ROCHESTER PRESERVATION BOARD
STAFF REPORT
For hearing scheduled for May 4, 2016

A-011-15-16 28 Sibley Place

ROCHESTER PRESERVATION BOARD
STAFF REPORT
For hearing scheduled for May 4, 2016

A-042-15-16 383 Park Avenue

1 SOUTH ELEVATION
SCALE: 1"=15'-0"

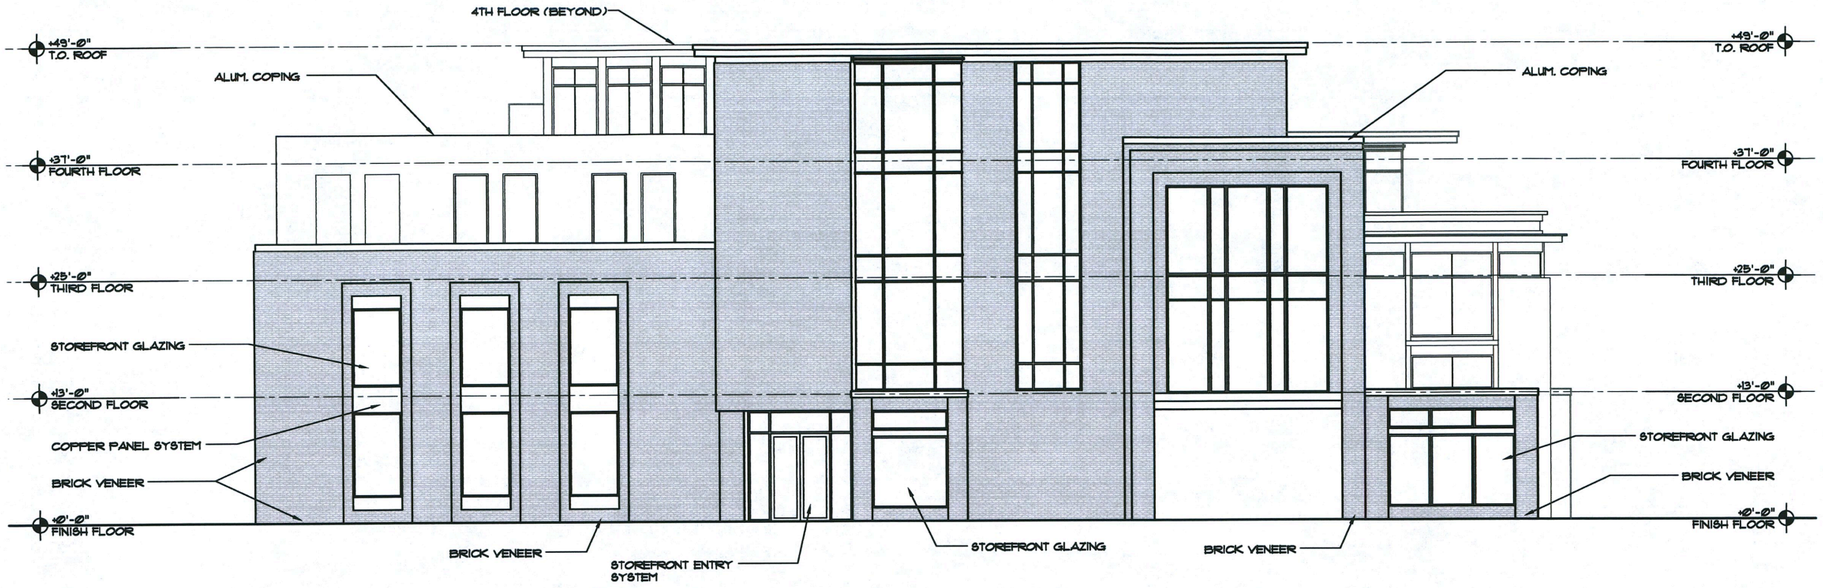
It is important to read this building as being just three stories at the front, with the fourth story tucked back. The streetscape elevation shows the three-story portion would be no taller than the Century Club. The fourth floor elevations need a bit of attention, as vertical alignments don't look quite right, especially on the east side.
